Type Coffee Vending Machine	Model 9100 - 95	N° T.I. 05 - 2019	
Serial Number 90511159	Subject "O - RING" CHANGE FOR PIN OF CAPILLARY THERMOSTAT	ISSUED FOR (X)	Action Information X

New OR gasket - 1,78X9,25

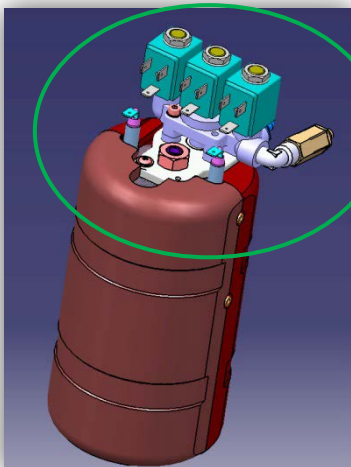
The **OR** for the **pin** of *boiler capillary protector* has been replaced by a new one.

Pre - modific. OR gasket - 1,78X7,65

Spare code: **094594**

Spare code: **257077**

Boiler assembly

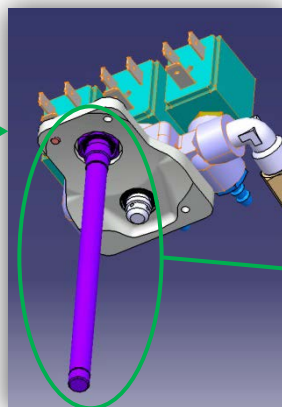
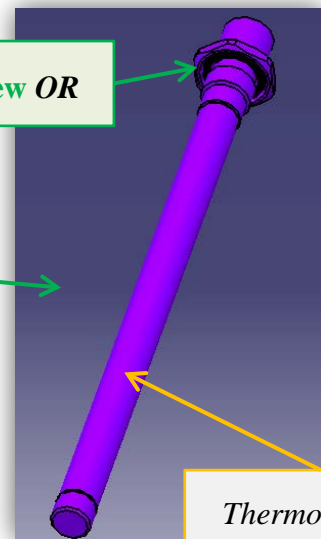
New OR

Thermostat *pin*
